**Telecommunications and exchange
between information technology
systems — Requirements for local and
metropolitan area networks —**

**Part 3:
Standard for Ethernet**

**AMENDMENT 1: Physical layer
specifications and management
parameters for 2.5 Gb/s and 5 Gb/s
operation over backplane**

Amendment 1: Physical Layer Specifications and Management Parameters for 2.5 Gb/s and 5 Gb/s Operation over Backplane

Figure 69-4—Architectural positioning of 2.5 Gb/s and 5 Gb/s Backplane Ethernet

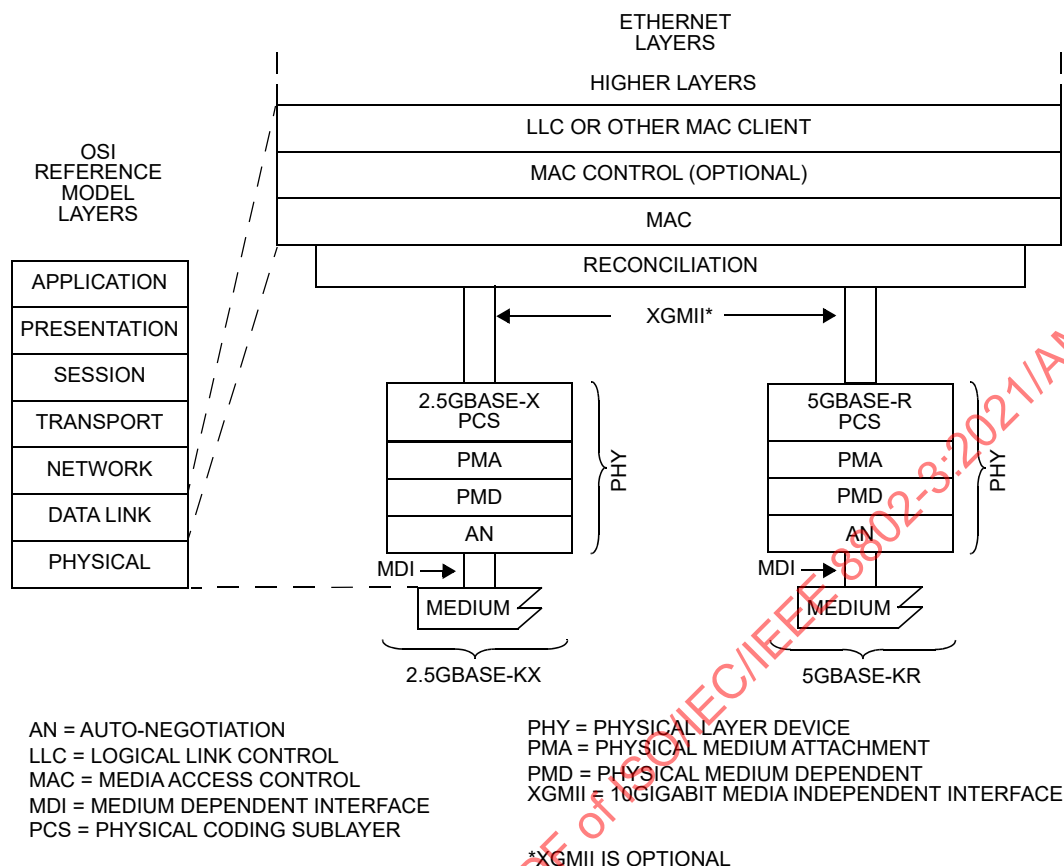
Insert the new figure on the next page (Figure 69-4) after Figure 69-3.

Figure 73–1—Location of Auto-Negotiation function within the ISO/IEC OSI reference model

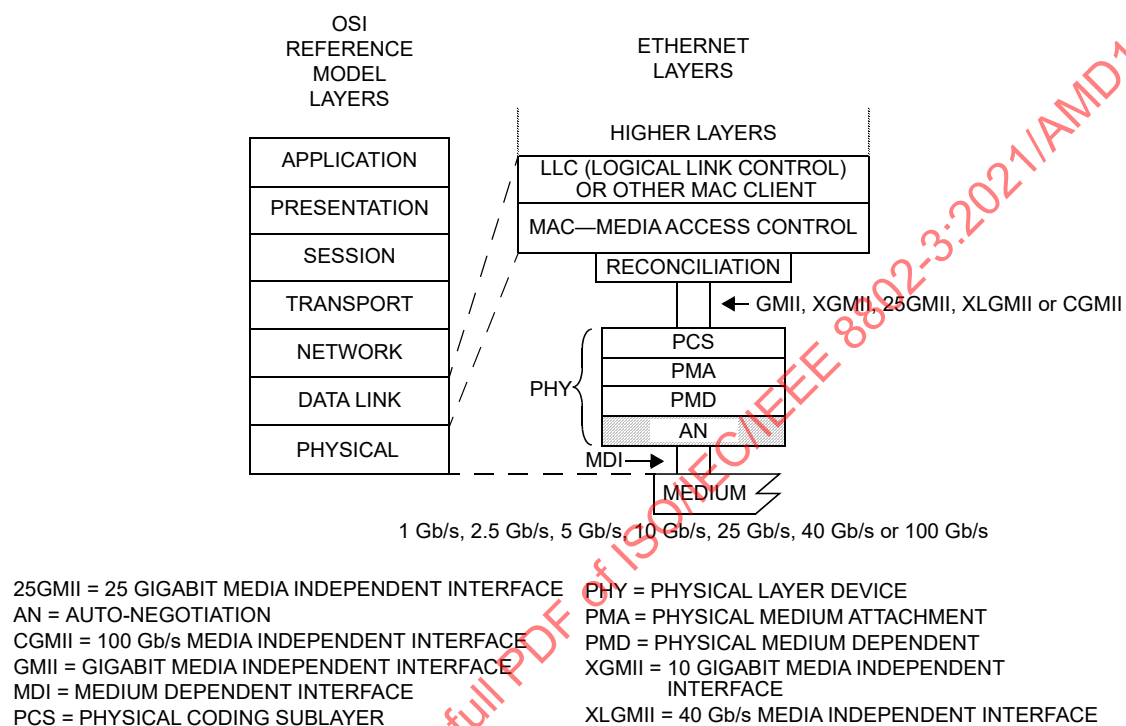
Replace Figure 73–1 with the following figure (which adds 2.5 Gb/s and 5 Gb/s in the medium rates):

Figure 125-1—Architectural positioning of 2.5 Gigabit and 5 Gigabit Ethernet

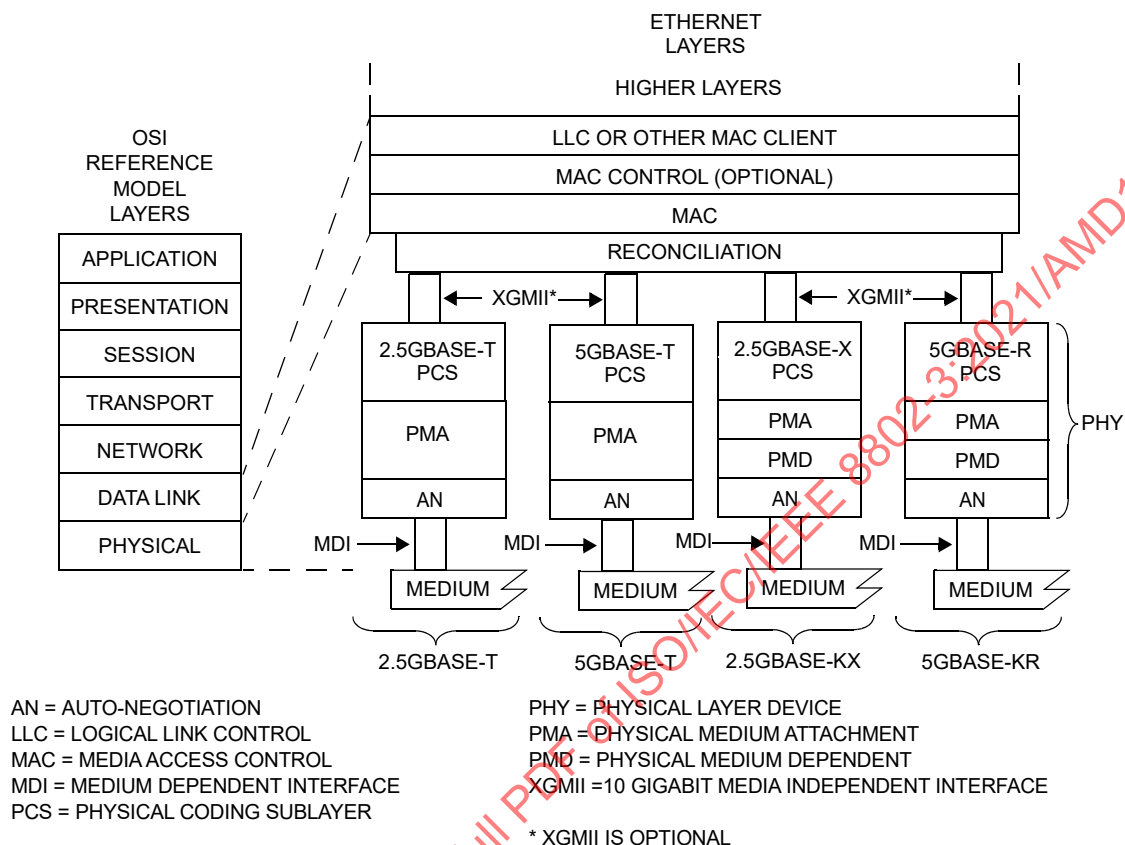
Replace Figure 125-1 with the following figure (which adds the 2.5GBASE-KX and 5GBASE-KR related layer diagram):

Figure 69B–2—Fitted attenuation limit for 1000BASE-KX, 10GBASE-KX4, 10GBASE-KR, and 40GBASE-KR4

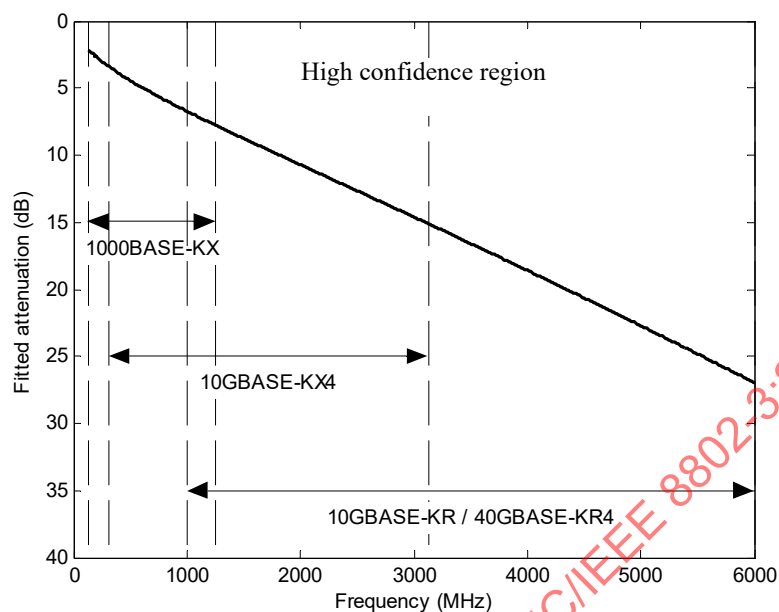
Change the title of Figure 69B–2 as shown (the figure art remains unchanged):

Figure 69B–2a—Fitted attenuation limit for 2.5GBASE-KX and 5GBASE-KR

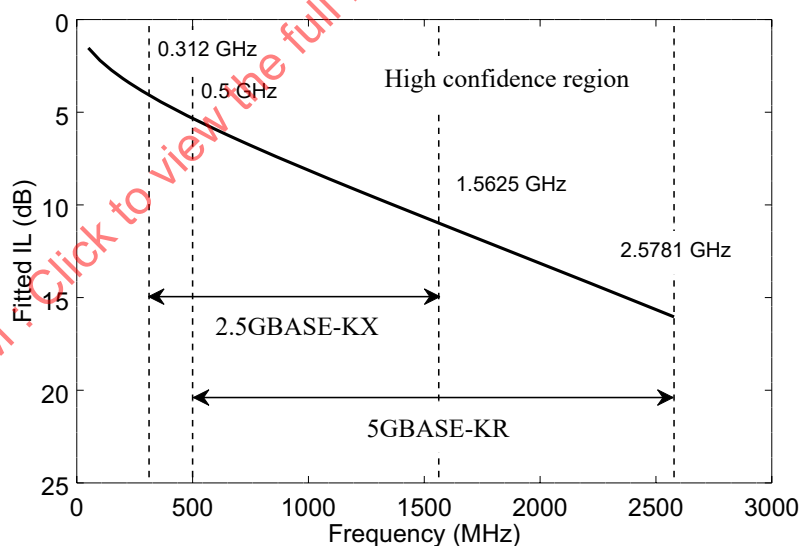
Insert the following new figure (Figure 69B–2a) after Figure 69B–2:

Figure 69B–5a—Insertion loss limit for 2.5GBASE-KX

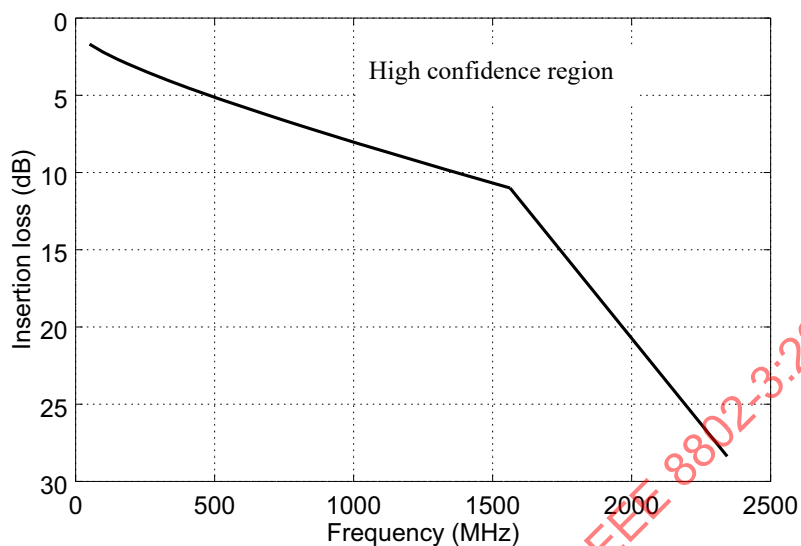
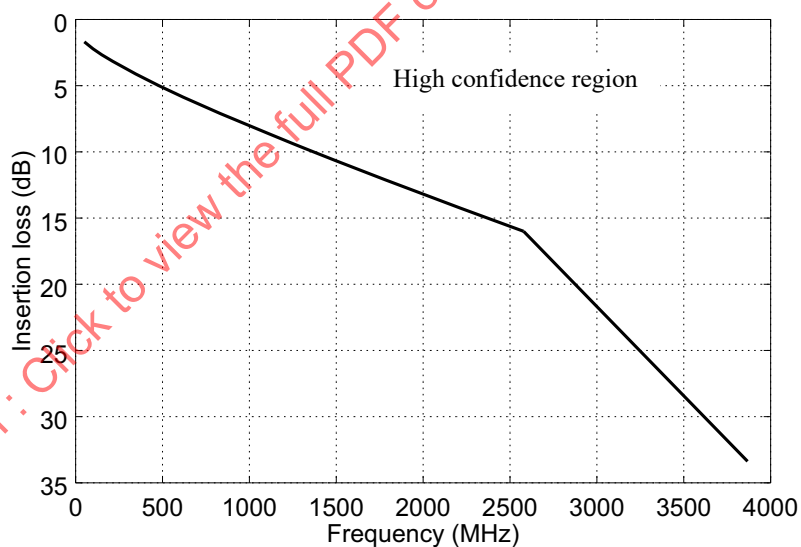
Insert the following new figures (Figure 69B–5a and Figure 69B–5b) after Figure 69B-5:

Figure 69B–6—Insertion loss deviation limits for 1000BASE-KX, 10GBASE-KX4, 10GBASE-KR, and 40GBASE-KR4

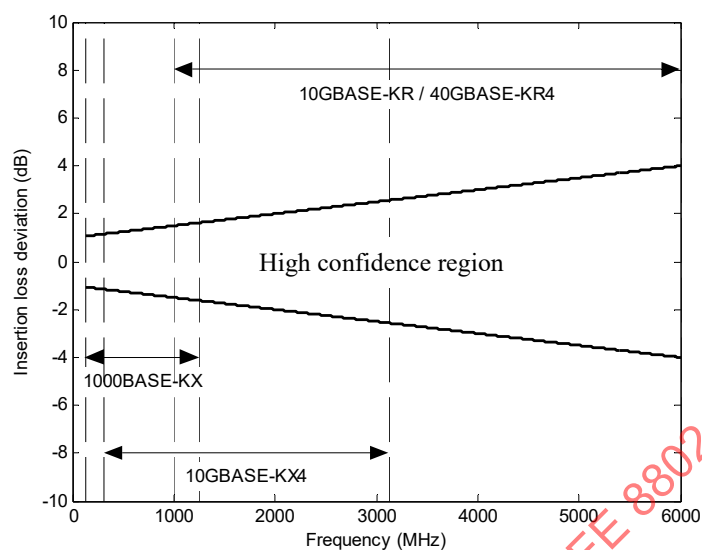
Change the title of Figure 69B–6 as shown (the figure art remains unchanged):

Figure 69B–6a—Insertion loss deviation limits for 2.5GBASE-KX and 5GBASE-KR

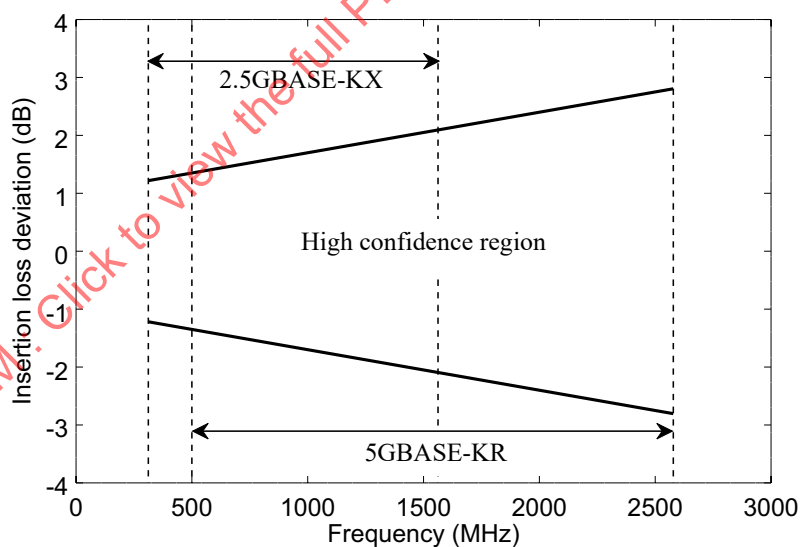
Insert the following new figure (Figure 69B–6a) after Figure 69B–6:

Figure 69B–7—Return loss limit for 1000BASE-KX, 10GBASE-KX4, 10GBASE-KR, and 40GBASE-KR4

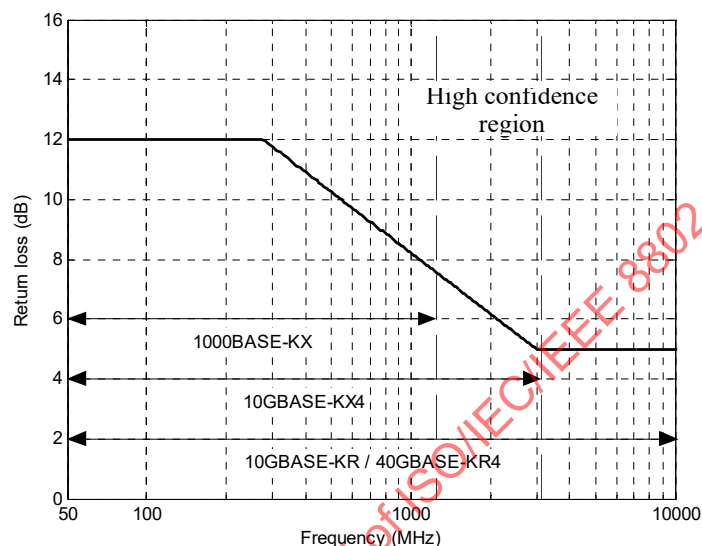
Change the title of Figure 69B–7 as shown (the figure art remains unchanged):

Figure 69B–7a—Return loss limit for 2.5GBASE-KX and 5GBASE-KR

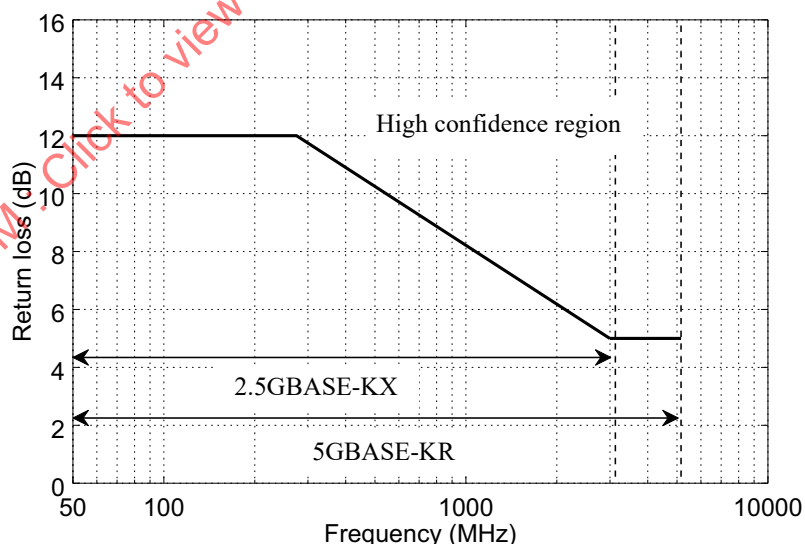
Insert the following new figure (Figure 69B–7a) after Figure 69B–7:

Figure 69B–8—Insertion loss to crosstalk ratio limit for 1000BASE-KX, 10GBASE-KX4, 10GBASE-KR, and 40GBASE-KR4

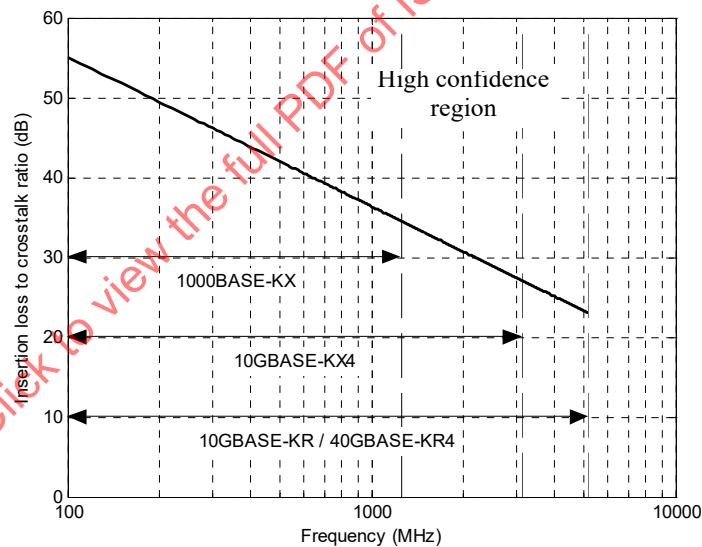
Change the title of Figure 69B–8 as shown (the figure art remains unchanged):

Figure 69B–9—Insertion loss to crosstalk ratio limit for 2.5GBASE-KX and 5GBASE-KR

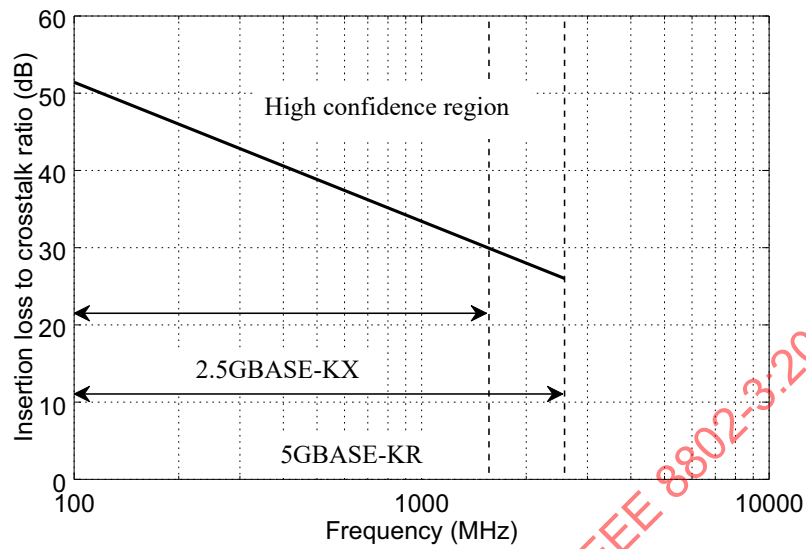
Insert the following new figure (Figure 69B–9) after Figure 69B–8:
